Staff Report

To: Salt Lake City Historic Landmark Commission
From: Sara Javoronok, AICP, Senior Planner, sara.javoronok@slcgov.com, 801-535-7625
Date: September 1, 2022
Re: PLNHLC2022-00724 – New Two-family Dwelling

New Construction

Sara Javoronok
Salt Lake City
451 South State Street, Room 406
PO Box 145480, Salt Lake City, UT 84114
RE: Comments from the updated plans

STREETSCAPE

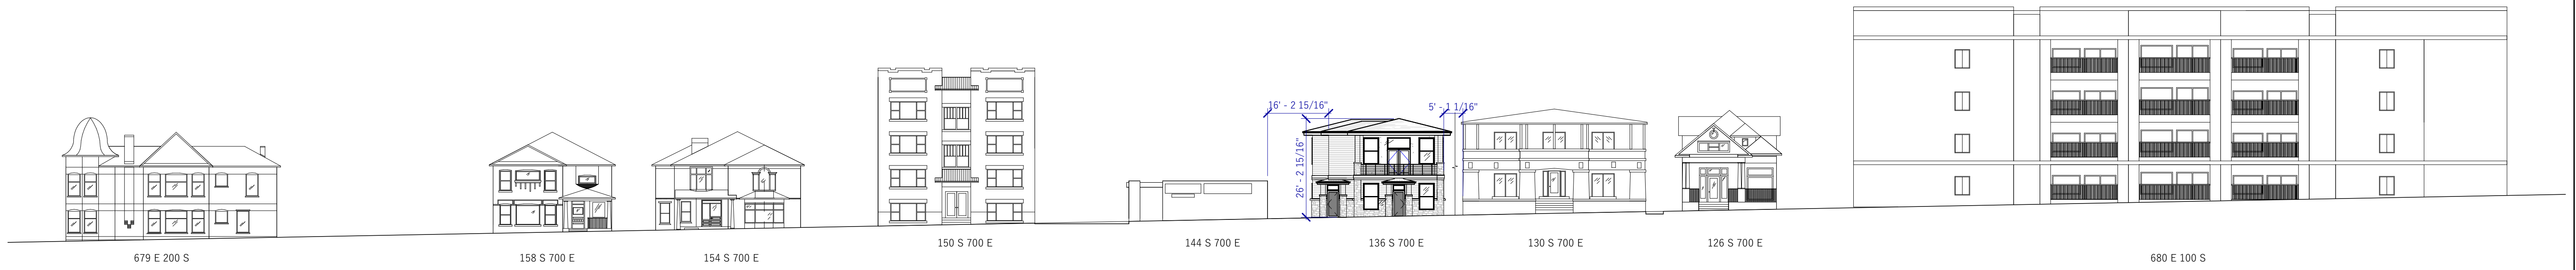
- A. Glass separated out from calculations for clarity.
- 10. The updated streetscape drawing is helpful for the review. We noticed that the rear entry and the rear portion of the building that extends to the south isn't on this view. Is it not visible from the street?**

- A. Street view has been updated to show that rear unit entry.
- 11. Provide the fence material and clearly identify the location of it if it's extending beyond the rear property line. See 21A.40.120 for fence regulations and Chapter 1: Site Features for guidelines – the material, location, and height should be compatible to those on contributing properties in the district.**

ARCHITECTURAL
 SITE PLAN

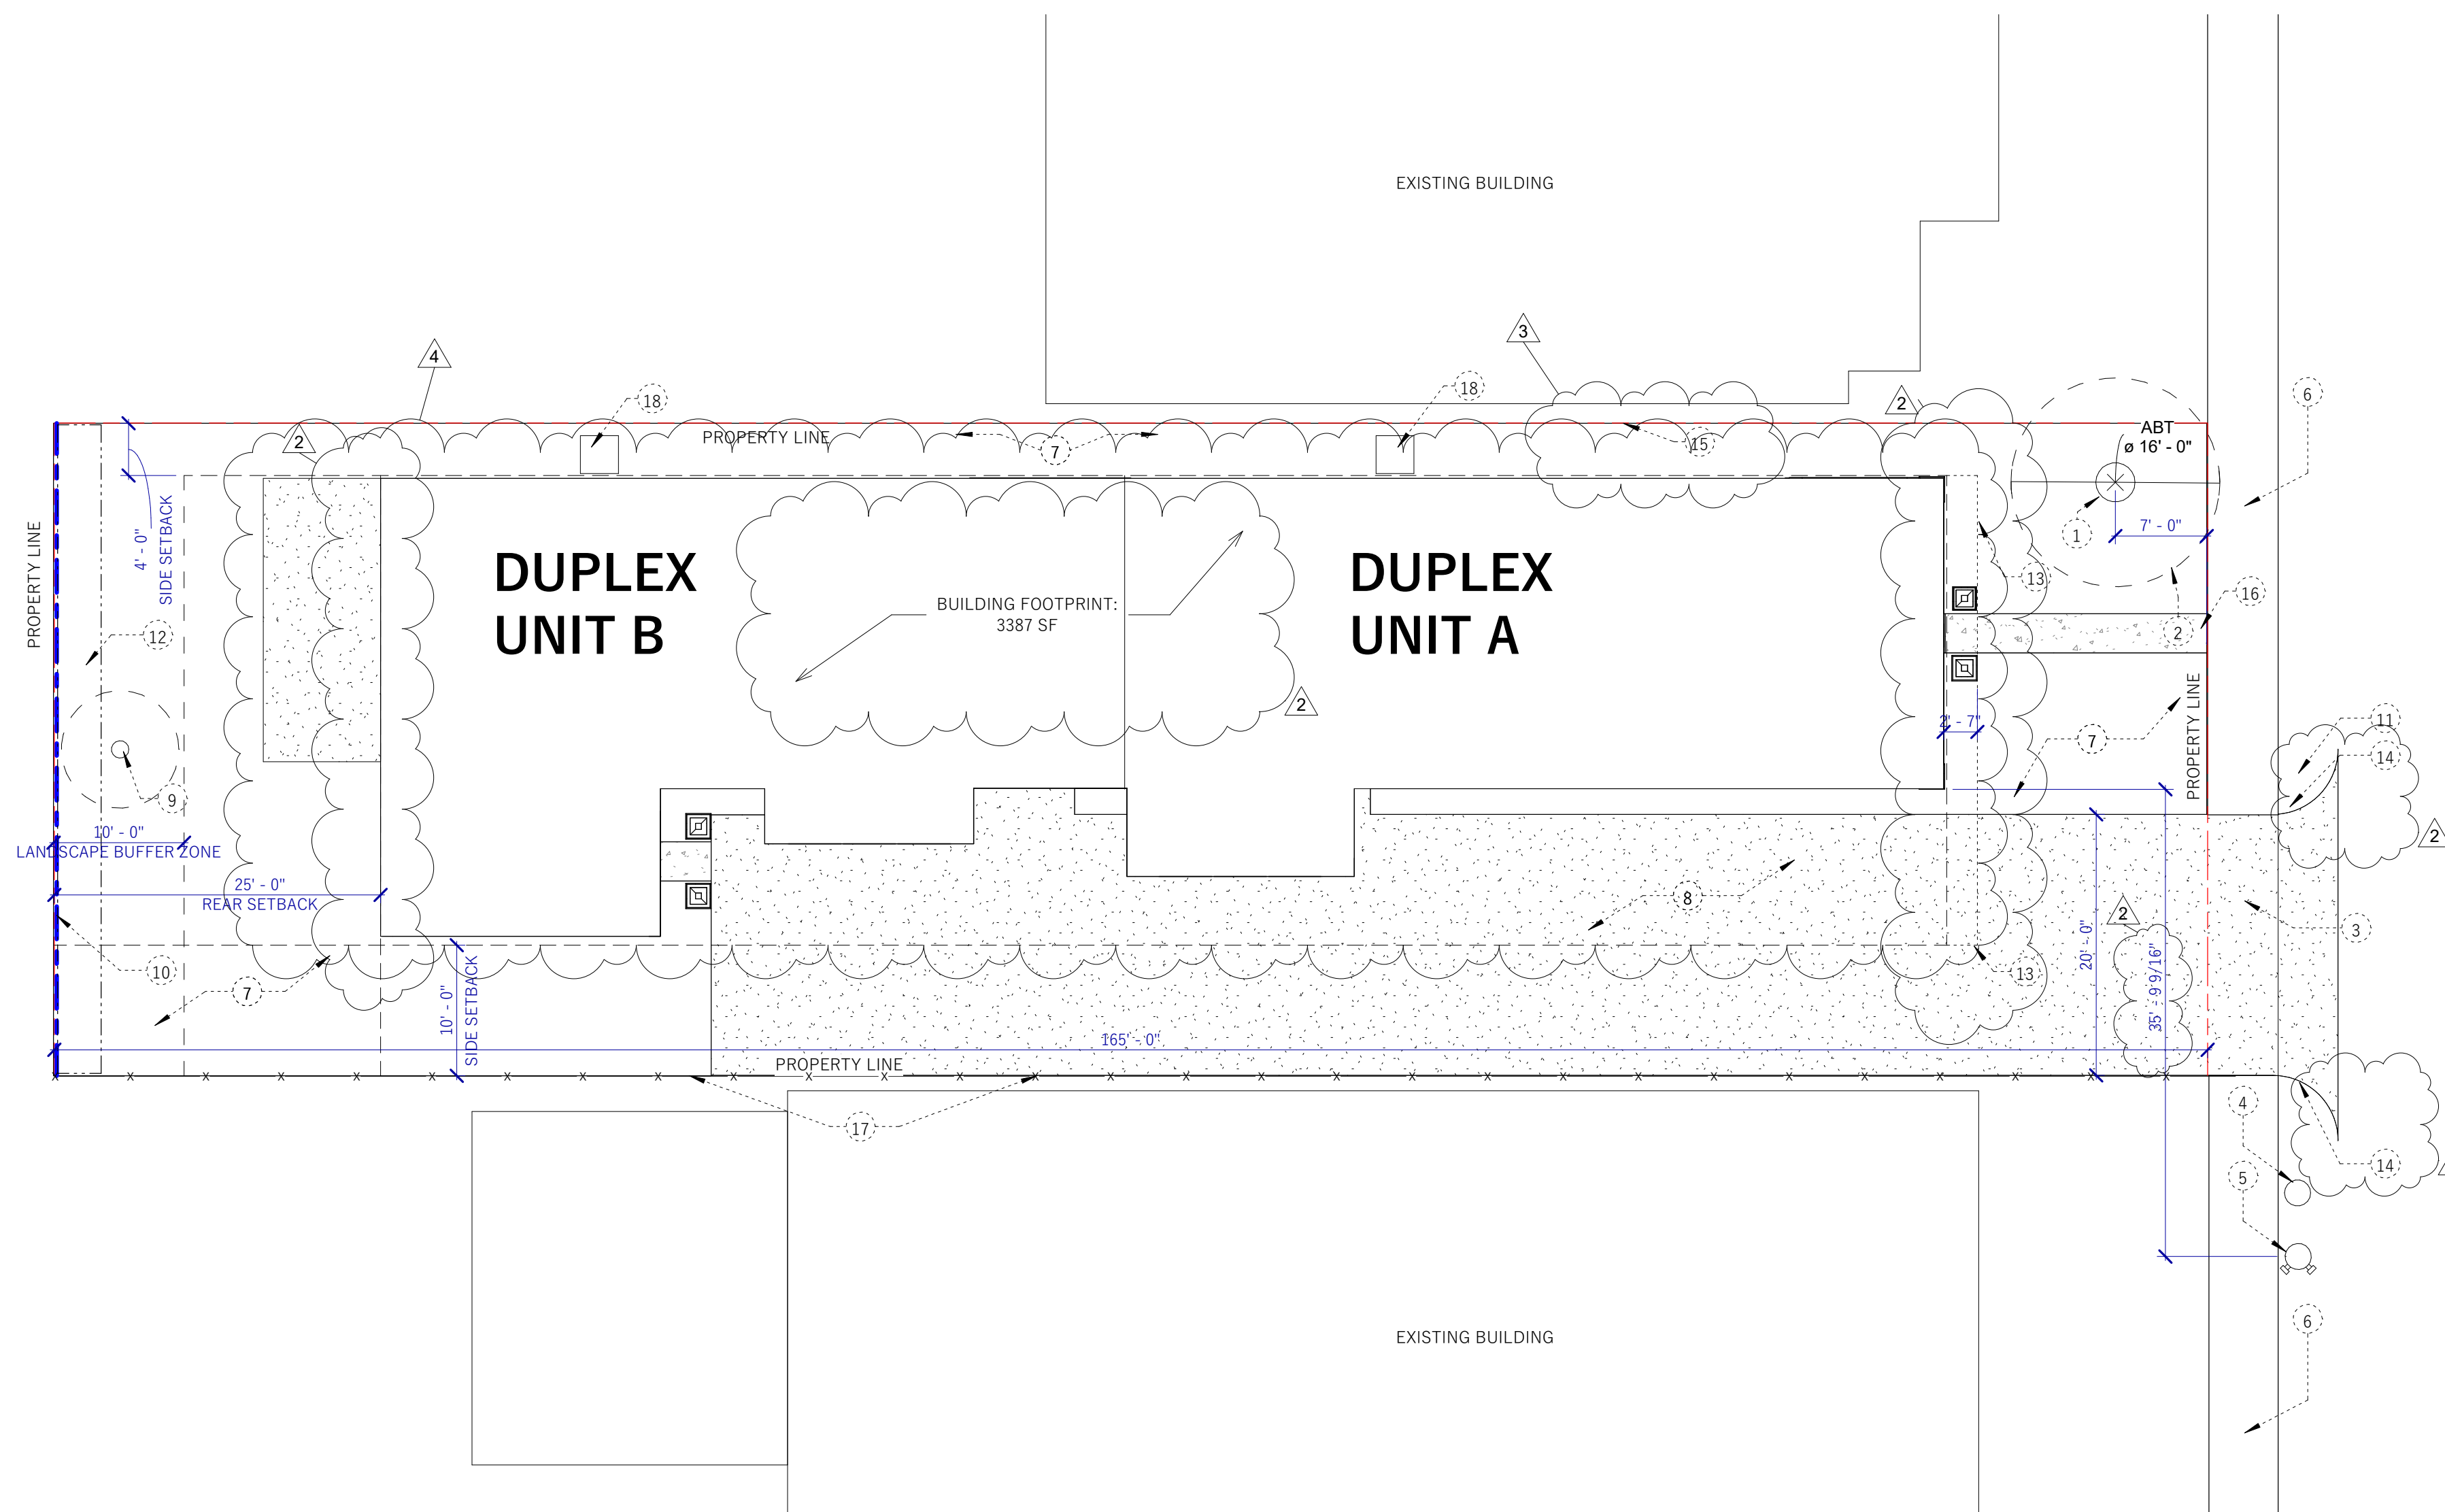
14	COORDINATE EDGE OF NEW CURB AND GUTTER WITH EXISTING CONDITIONS. REUSE EXISTING WHERE POSSIBLE.
15	EXISTING CHAIN-LINK FENCE TO REMAIN.
16	CONCRETE WALKWAY BETWEEN FRONT DOOR AND SIDEWALK. SEE CIVIL PLANS.
17	NEW VINYL FENCING TO MATCH VINYL FENCING AT REAR OF PROPERTY. EXTEND FROM BACK OF PROPERTY TO SIDEWALK ALONG STREET. SEE CIVIL.
18	PROPOSED CONDENSER UNIT LOCATION AS PER MECHANICAL.

- A. Existing fences noted on Architectural site plan and 1 new fence has been identified on the South of the lot to match existing fencing.
- 12. Identify the location of the condenser units or other HVAC equipment on the site plan.**

- A. Proposed condenser units have been located on Architectural Site Plan.
- 13. Additionally, with Hardi lap siding, traditionally wood siding did not have a textured finish and I will add a condition that it have a smooth finish.**

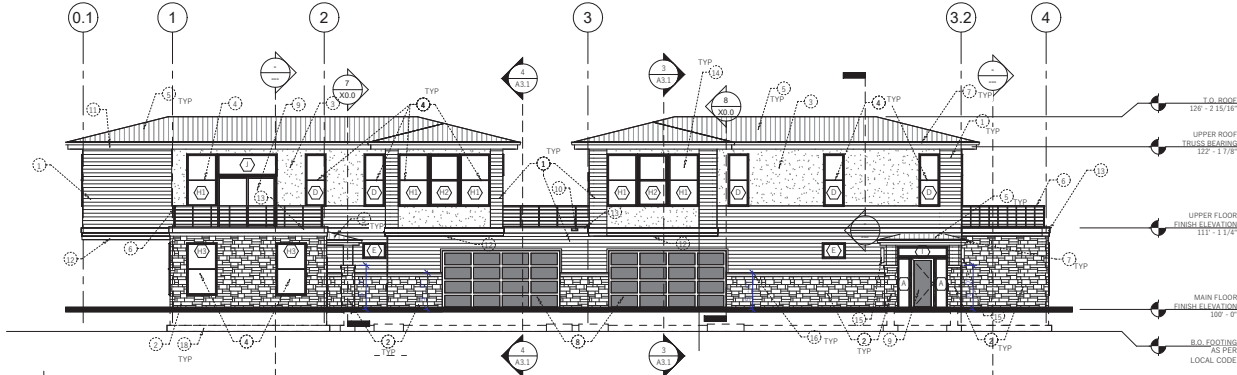
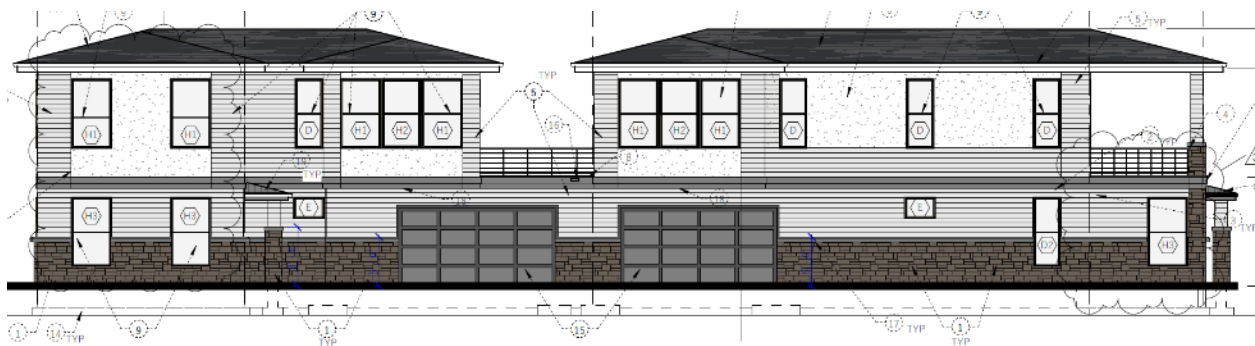
Changes made by the applicant on the front elevation include moving the entry to the front unit to the front elevation, the addition of the front entry porch, the addition of fiber cement siding on the front elevation, the covered second floor balcony, and French doors on the balcony. Additionally, the applicant changed the primary roofing material from standing seam metal to asphalt shingles and modified the projecting features to better meet building coverage requirements, modified openings, and added a pathway to the 700 East sidewalk. With the conditions, the applicant will meet the 80% durable materials requirement in 21A.34.020.H.6.a.
